MEETING SUMMARY
BRUNSWICK HYDROELECTRIC PROJECT
FERC NO. 2284
UPSTREAM FISH PASSAGE ALTERNATIVES MEETING
March 5, 2026

Attachment 1-Upstream Fish Passage Alternatives Matrix and Conceptual Sketches

"Free the Andro" NLF Option

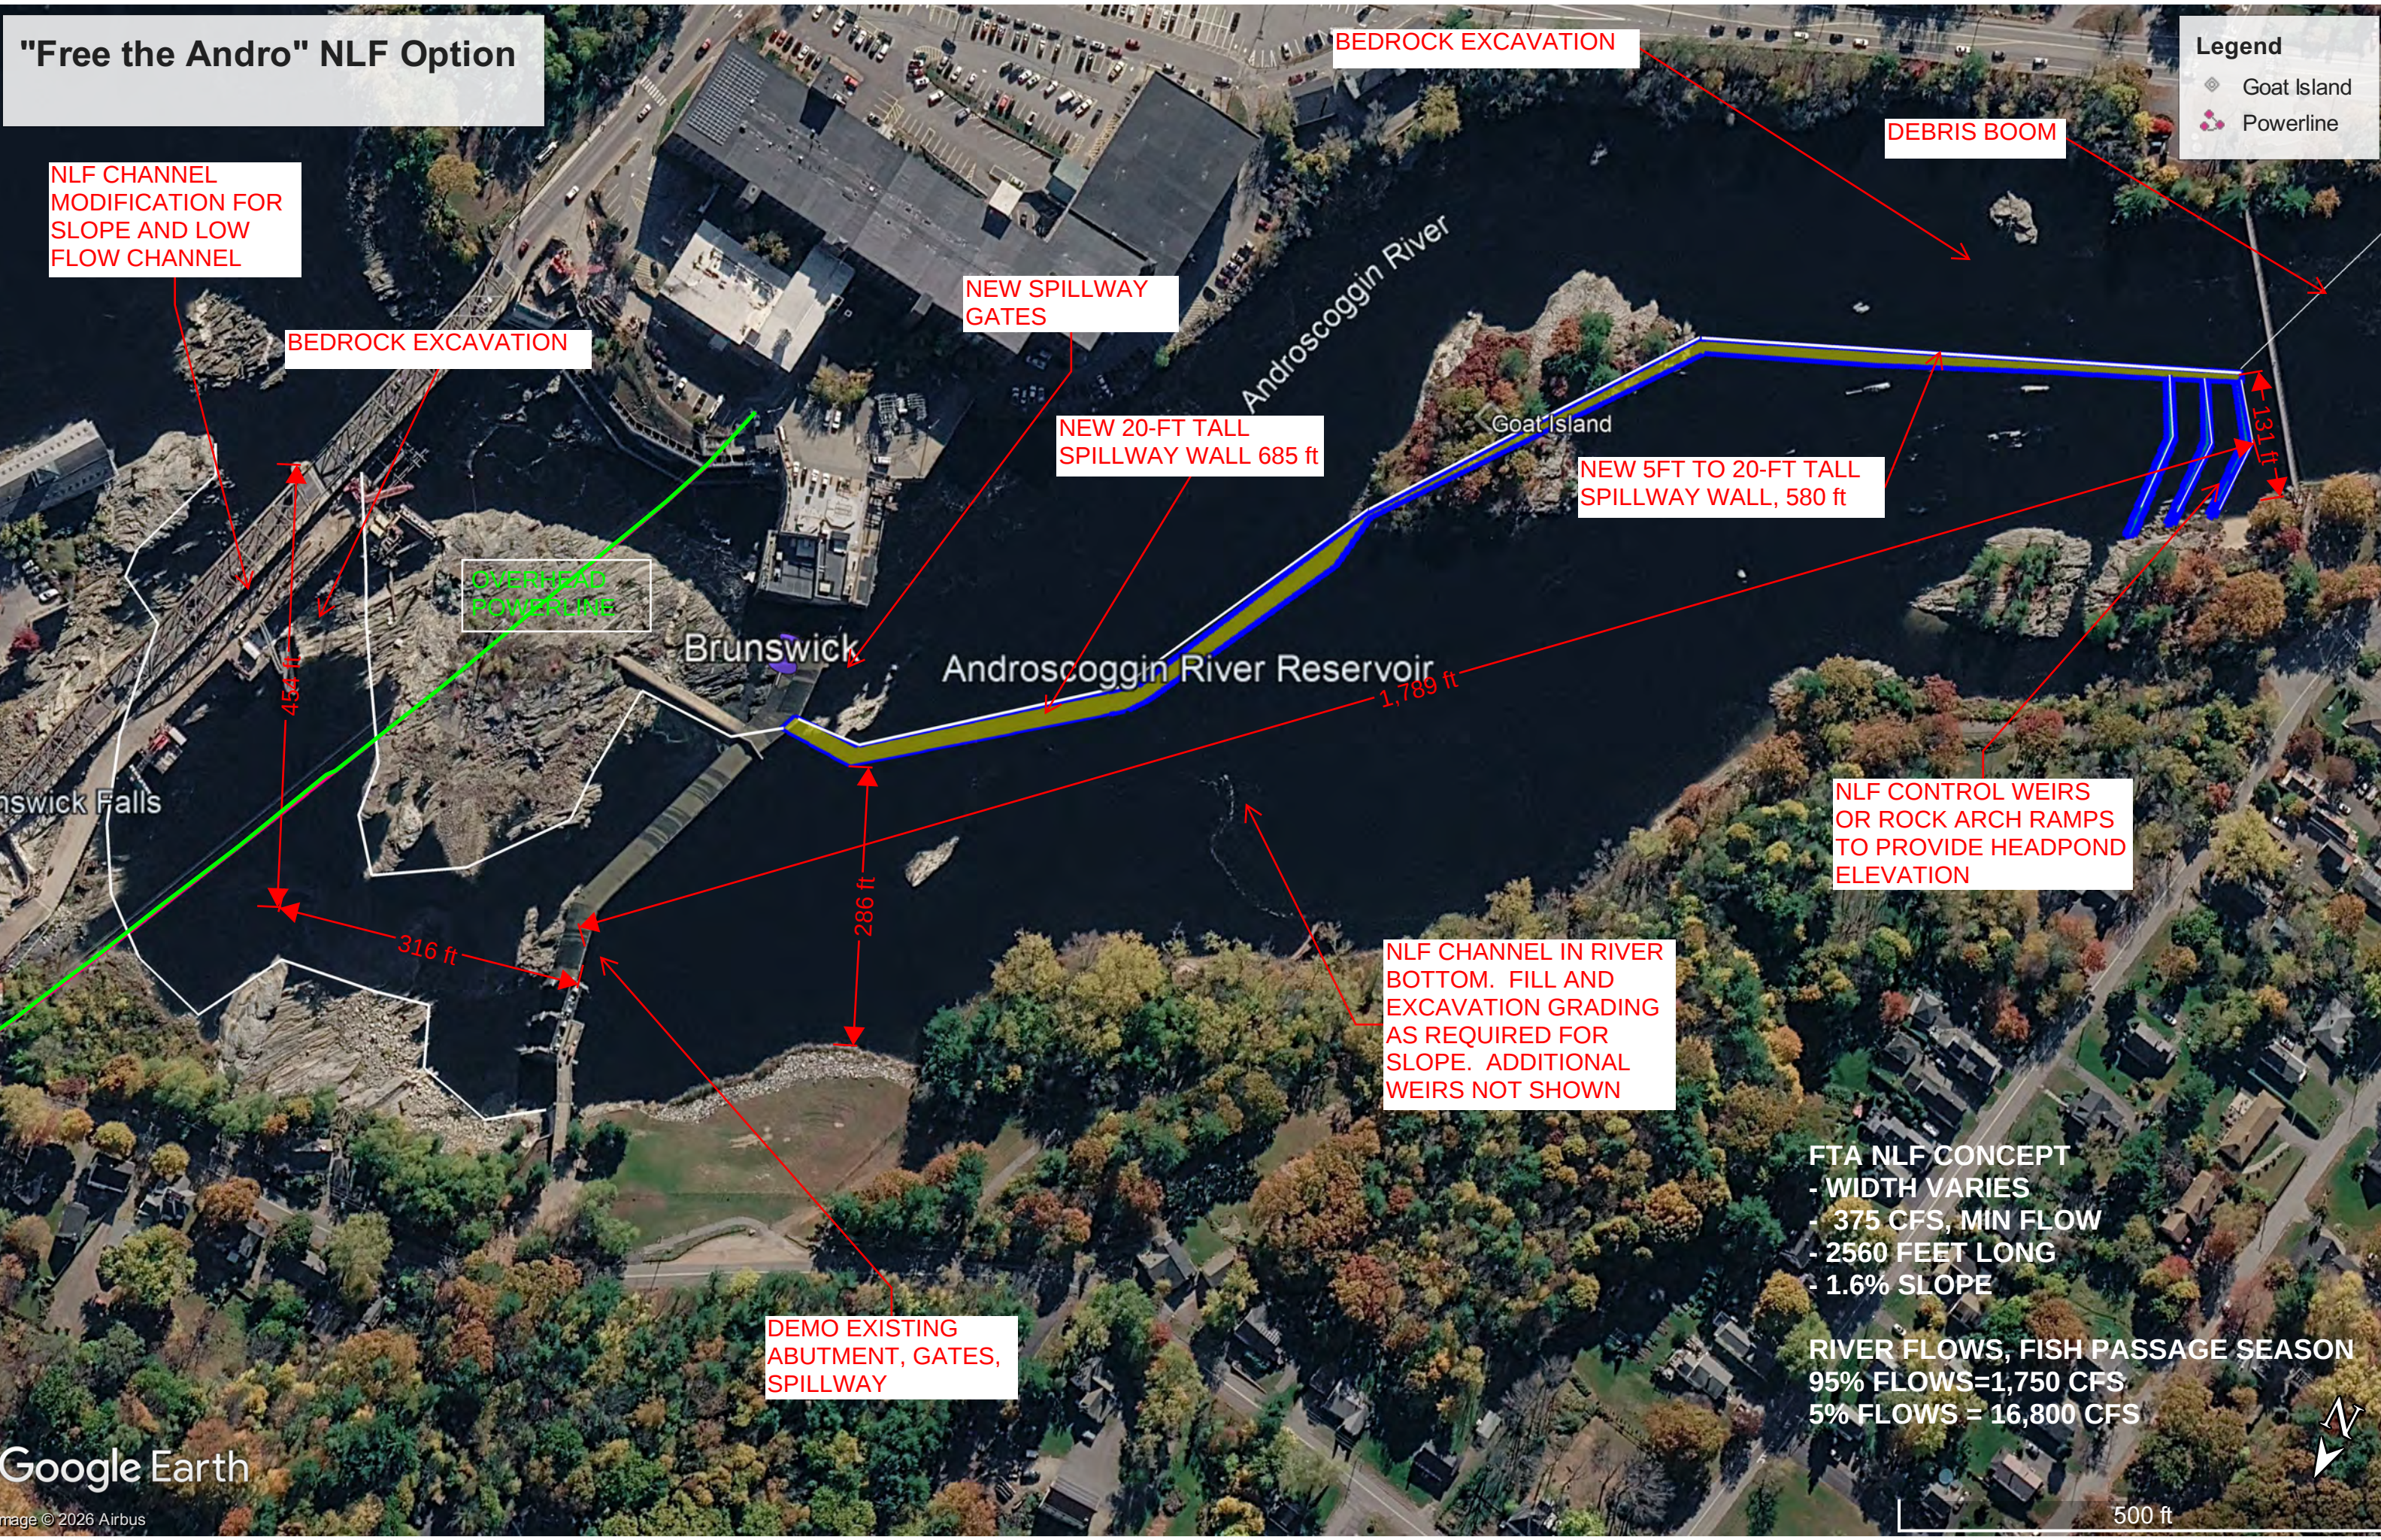
Vladimir Douhovnikoff suggested carrying this option forward through costed feasibility given stakeholder interest. Don Dow stated his support for advancing this alternative to feasibility assessment level development despite also acknowledging that Nature-Like

Fishways are not proven universally superior to technical fishways. Don would like to better understand the earthwork and spill modifications that would be required from an engineering and cost perspective.

Lucas Stiles stated that one concern with the Nature-Like Fishway alternatives is the location of the entrance is far downstream of the powerhouse, and fish may not be attracted to it. Lars Hammer reports seeing many river herring and some American Shad congregated below Shad Falls during a stranding survey with no spill across the Tainter gates. Ed Friedman suggested deliberate Tainter gate flow pulses coupled with acoustic monitoring to test whether attraction shifts toward the left channel from other areas (e.g., just downstream of the powerhouse). Kirk Smith suggested that the Project Interactions Telemetry Study might be a better method to determine fish attraction in this area, as well as other areas below the Project.

Lucas Stiles explained that this concept includes demolishing and modifying the spillway from Shad Island to the left-bank and building a new spillway wall up to Goat Island (see [Attachment 1](#)). This would also include constructing a 2,500 foot long (1.6% slope) Nature-Like Fishway along the river left portion of the river. The major technical challenges of this alternative include large cofferdams, spill capacity/ice/debris passage, substantial rock excavation (at downstream end), substantial in river fill (at upstream end), and shoreline grade adjustments. Downstream passage protection measures at the powerhouse would still be required since the Nature-Like Fishway entrance cannot exclude potential entrainment from the turbines.
